SMEE – CE Mesures is applying (on behalf of MUZIK LLC) for a Class II Permissive Change to the MUZIK Smart-on-ear equipment.

FCC ID: 2AASDMZHP1

Model: Smart-on-ear

Headphone Improvements List

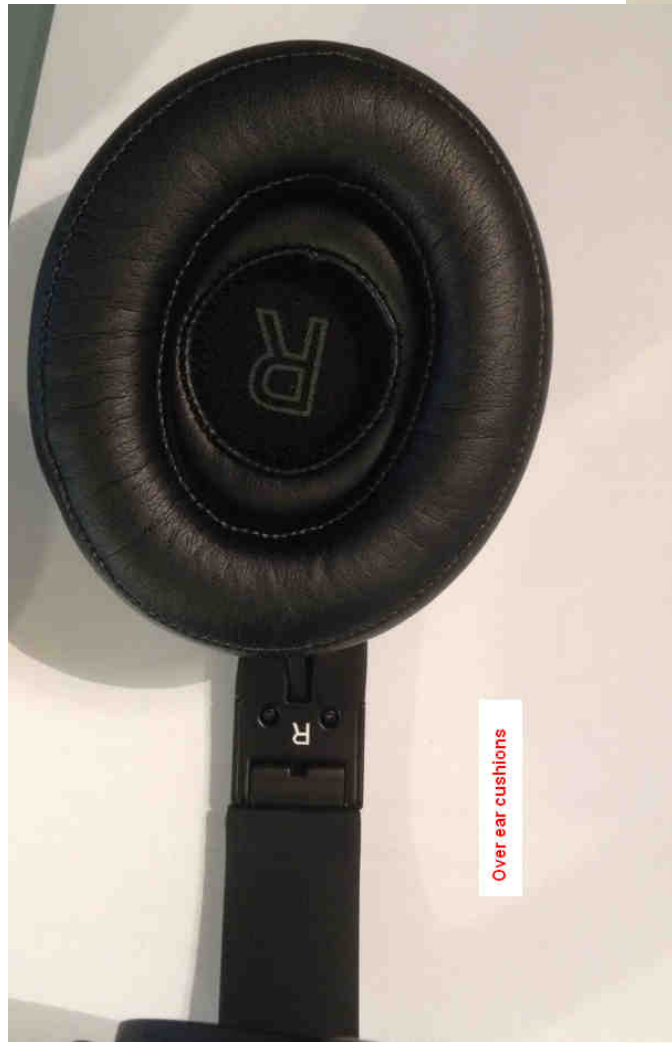
- Removable cushion attached by magnets
- 2 sizes of cushions on-ear and over-ear
- Silicone headband construction with foam
- Silicone headband assembly with plastic clip instead of 3M tape

Removable cushions attached with 4 magnets

- Add Foam below Silicone rubber headband to Improve comfort
- Change assembly of silicone headband, plastic clip instead of 3M tape

- Replace proximity copper antenna by wire antenna
- Change Battery size 700mAh to 800mAh
- Simplify PCBA layout delete components who were not populated

Proximity Antenna

Battery
